Product Change Notification: MFOL-04DBHB057

CCB 6183.003 Final Notice: Qualification of MTAI as a new final test site for AT24MAC602-STUM-T, AT24CS04-STUM-T, AT24MAC402-STUM-T, AT24CS16-STUM-T, AT24CS32-STUM-T, AT24CS01-STUM-T, AT24CS08-STUM-T, and AT24CS02-STUM-T catalog part numbers (CPN) available in 5L TSOT (1.6x2.9x1.1mm) package.

CCB 6183.003
Pre and Post Change Summary
PCN #: MFOL-04DBHB057

Pre and Post Change Summary - Pin1 Orientation

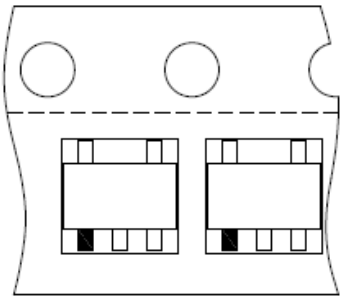
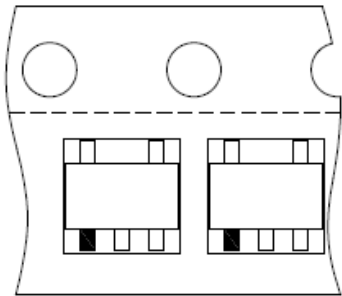
ATP7	MTAI								
<div data-bbox="522 406 861 699"></div> <div data-bbox="606 711 777 879"><table><tr><td>1</td><td>2</td></tr><tr><td>3</td><td>4</td></tr></table></div> <div data-bbox="570 921 789 968"><p>Quadrant 3</p></div>	1	2	3	4	<div data-bbox="1696 425 2035 718"></div> <div data-bbox="1778 729 1949 898"><table><tr><td>1</td><td>2</td></tr><tr><td>3</td><td>4</td></tr></table></div> <div data-bbox="1755 921 1974 968"><p>Quadrant 3</p></div>	1	2	3	4
1	2								
3	4								
1	2								
3	4

Pre and Post Change Summary – Carrier Tape

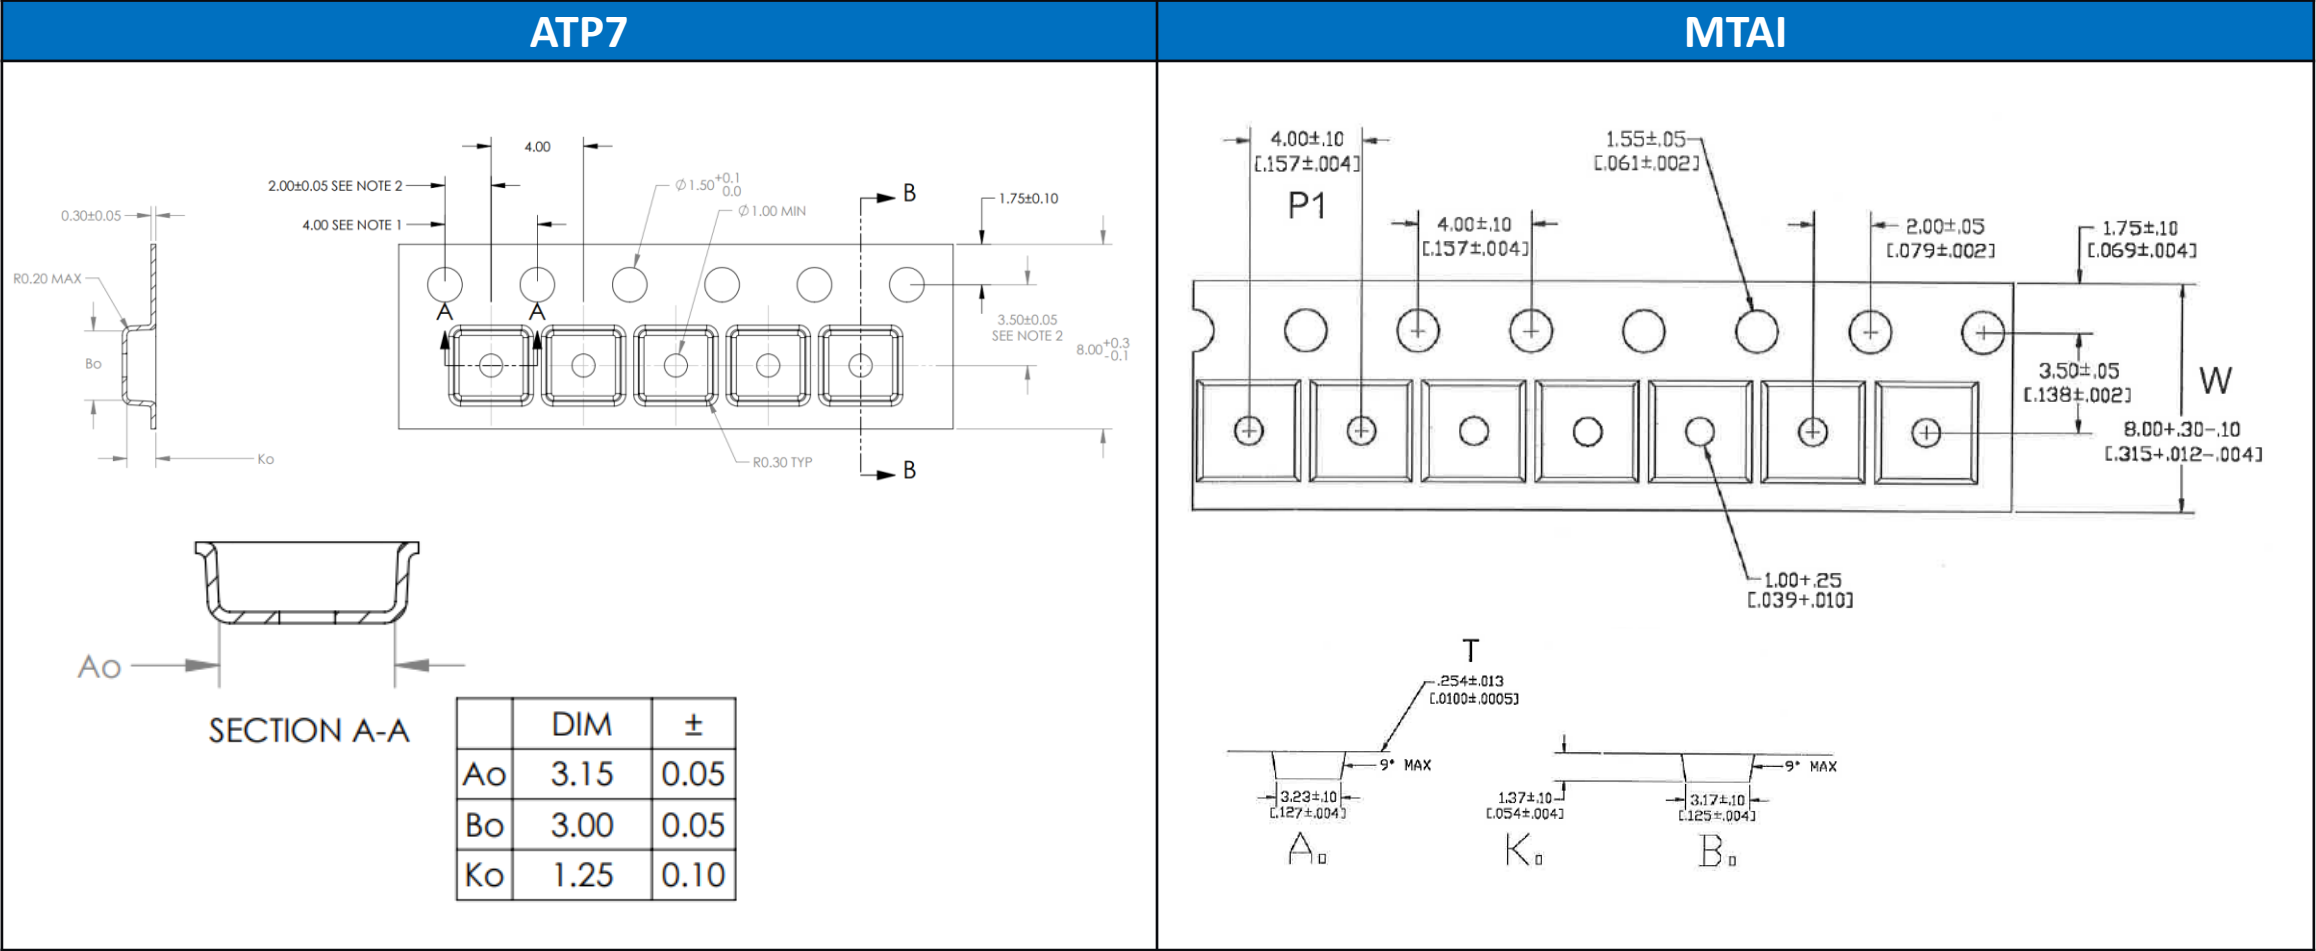
Plant	W (mm)	P (mm)	A0 (mm)	B0 (mm)	K0 (mm)	Thickness (mm)
ATP7	8.00 +0.30/-0.10	4.00 ±0.10	3.15 ±0.05	3.00 ±0.05	1.25 ±0.10	0.30 ± 0.05
MTAI	8.00 +0.30/-0.10	4.00 ±0.10	3.23 ±0.10	3.17 ±0.10	1.37 ±0.10	0.254 ±0.013

Pre and Post Change Summary – Cover Tape

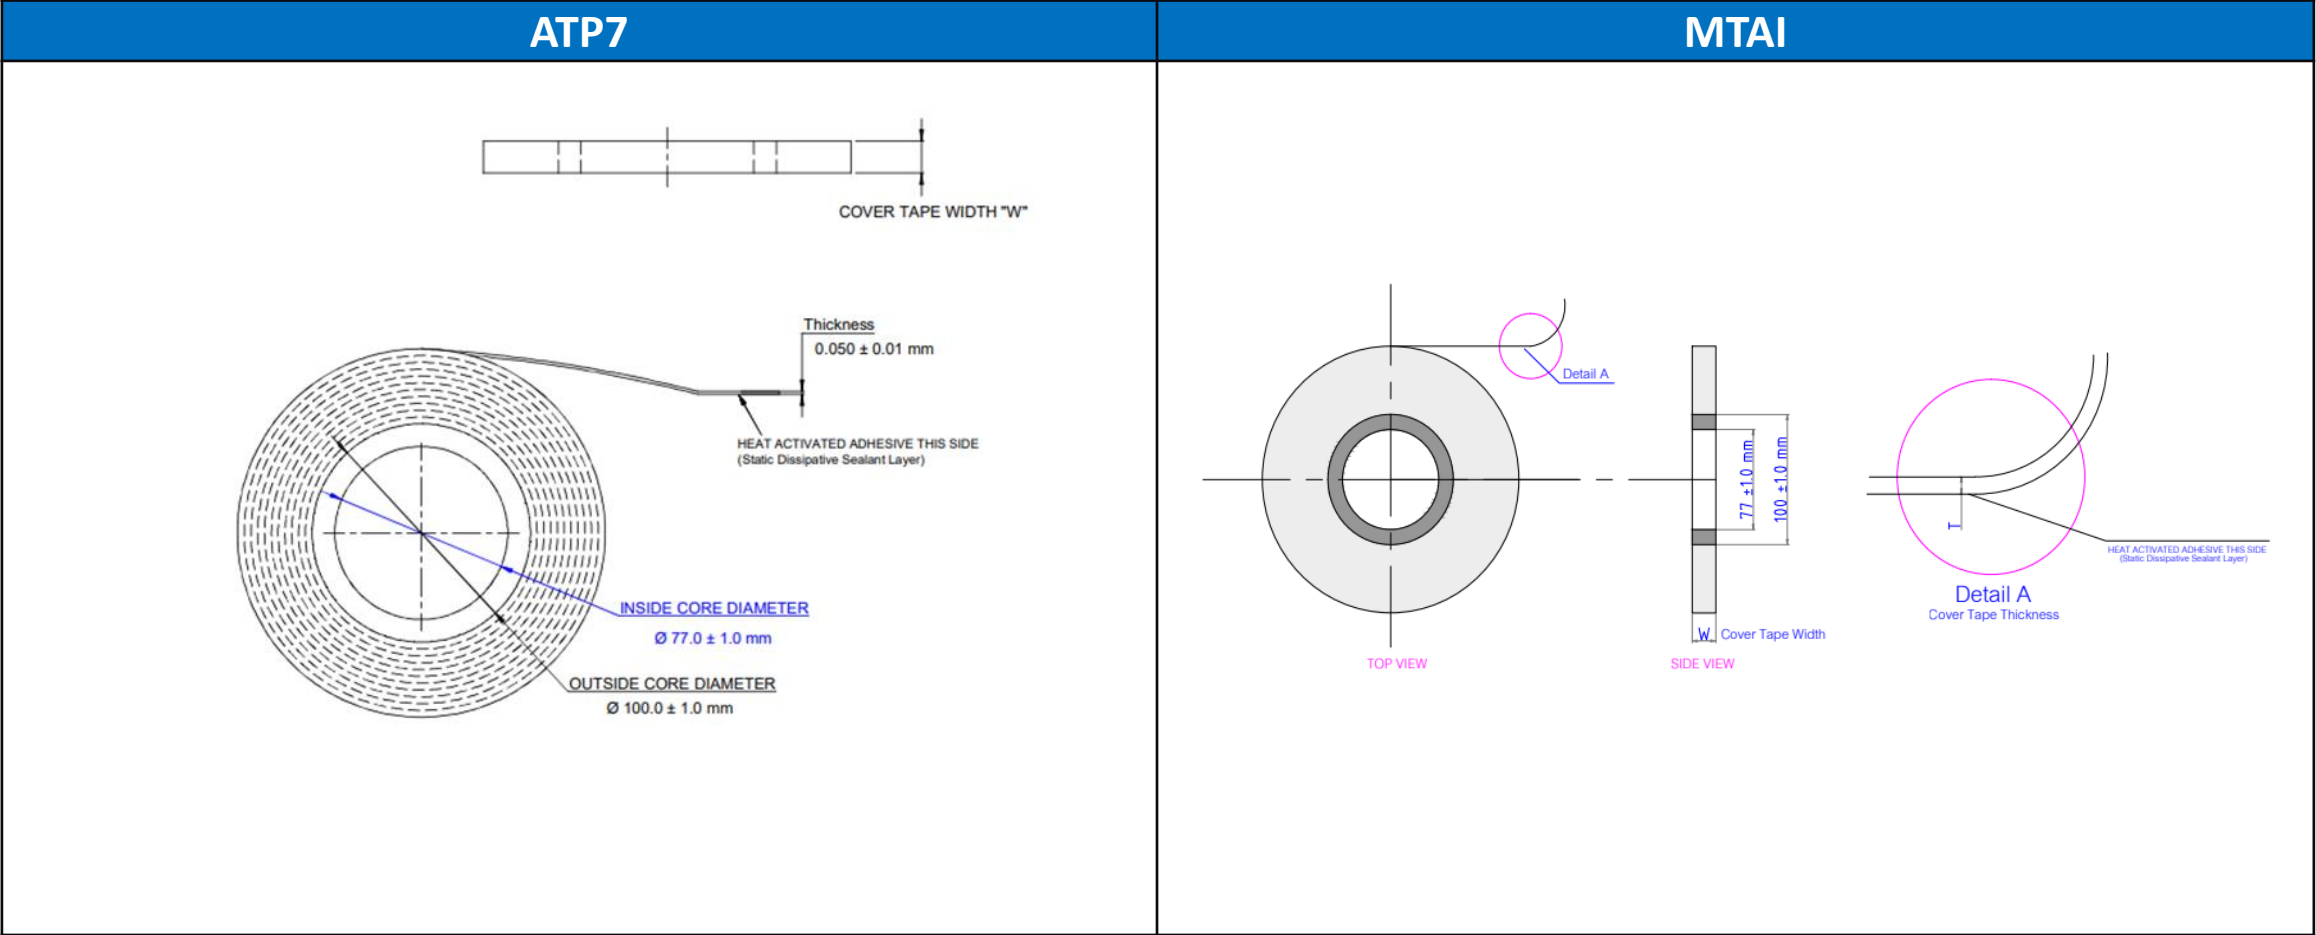
Plant	Width W (mm.)	Thickness T (mm.)	Color	Sealing Methodology
ATP7	5.4 +/- 0.10	0.050 +/- 0.01	Gray	Heat Seal
MTAI	5.4 ±0.1	0.062 ±0.013	Clear	Heat sealing

Pre and Post Change Summary - Reel

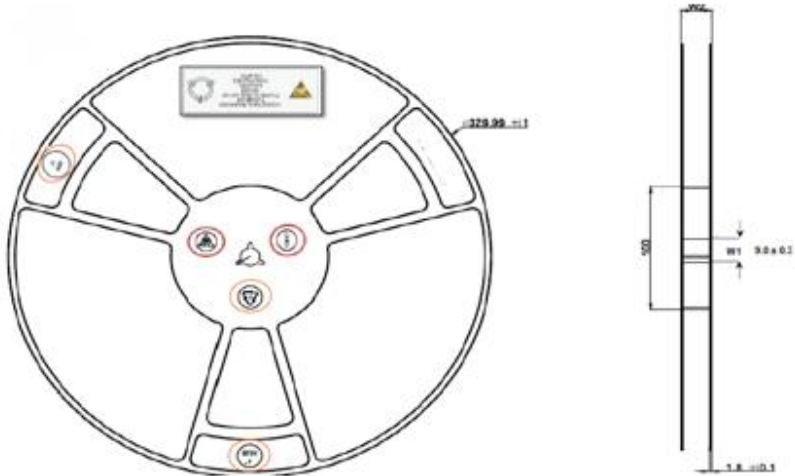
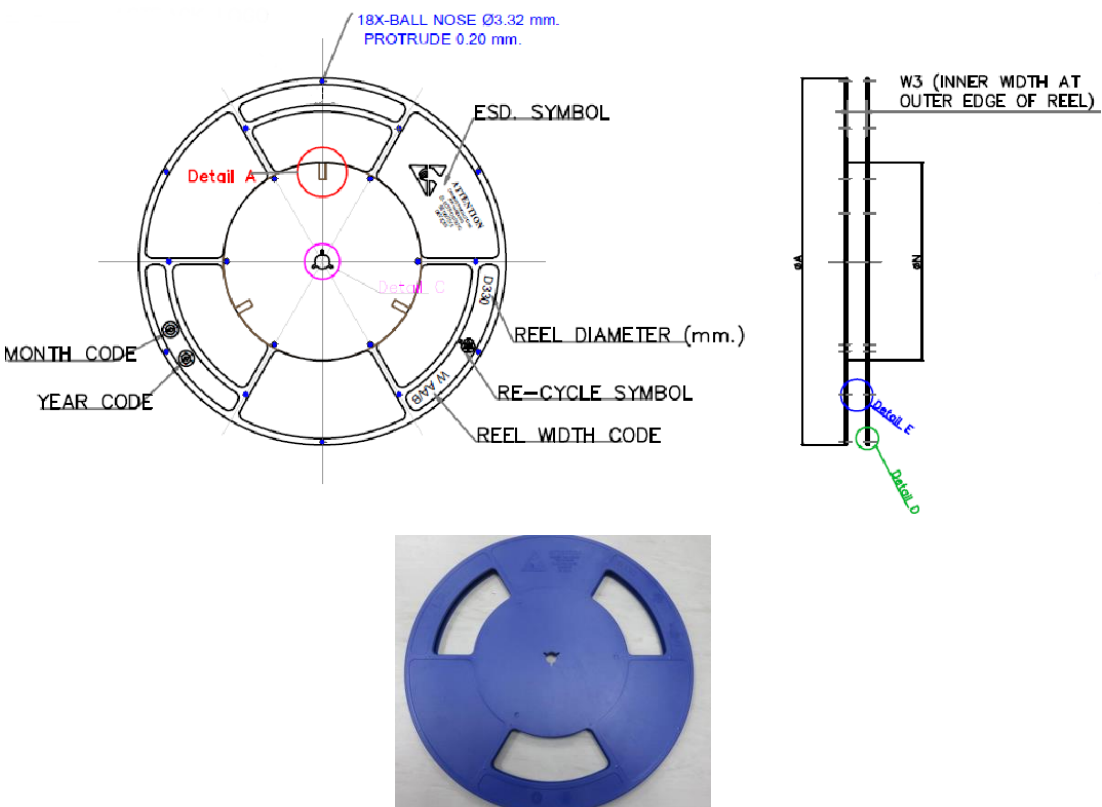
Plant	Reel Diameter (mm.)	Reel Hub Size (mm)	Reel Width Max (mm.)	Color
ATP7	329.99±1	100	11.4±0.0.8	White
MTAI	330 ±2.0	178 +0/- 2.0	14.40	Dark Blue

Pre and Post Change Summary – Shielding Bag

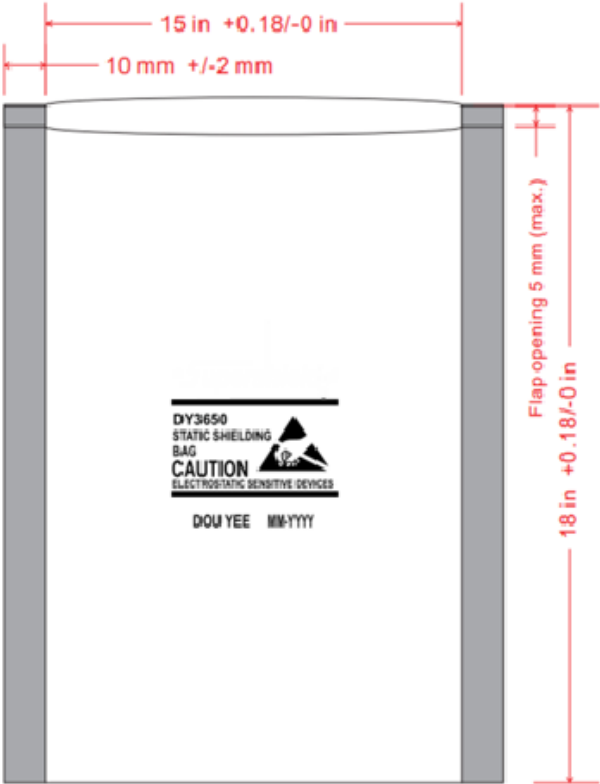
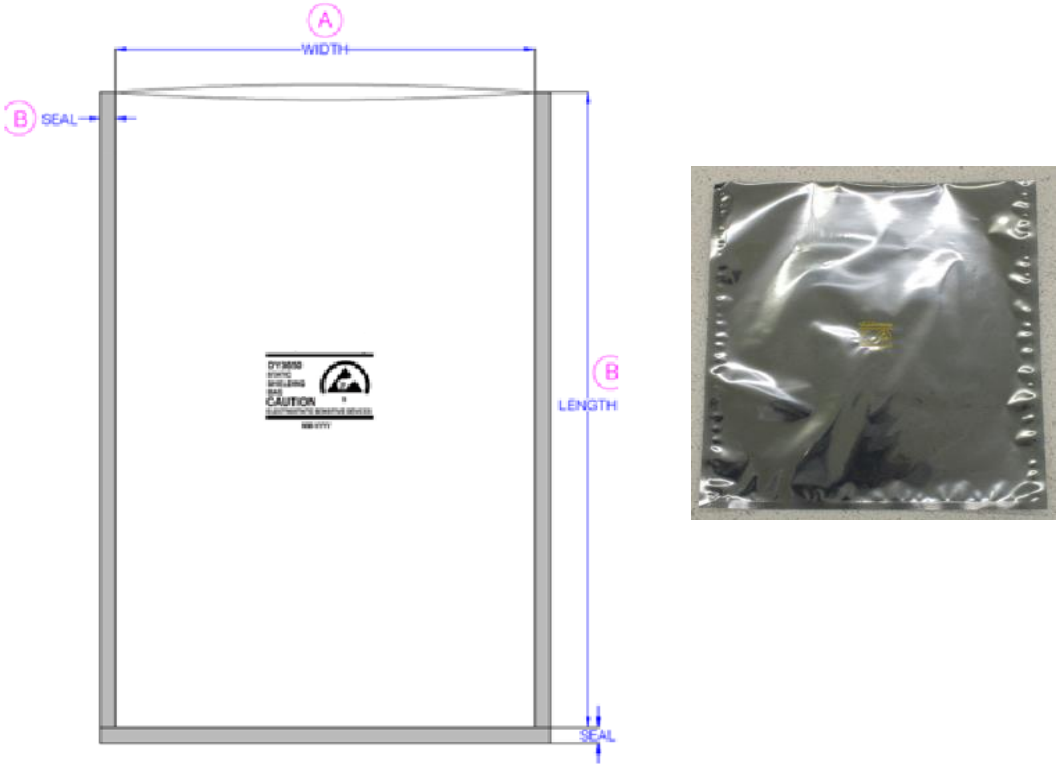
Plant	Bag type	Length (mm)	Width (mm)	Thickness (mm)
ATP7	Static Shielding Bag	482.6 +4.5/-0	381 +4.5/-0	3.0 +/- 0.3
MTAI	Static Shielding Bag	420 +5/-0	370 +5/-0	0.0762

Pre and Post Change Summary – Packing Method

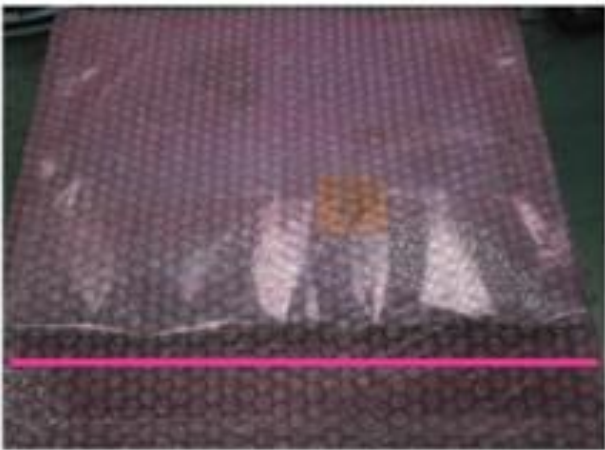
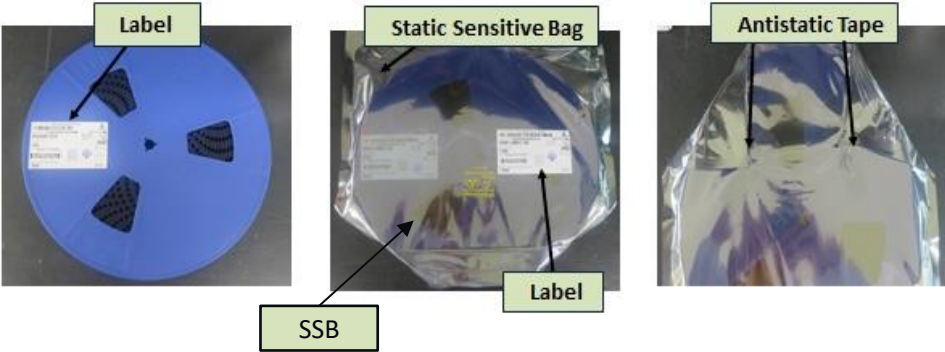
MSL-1 (No inner box)

Carton for product in T/R media (MSL-1)
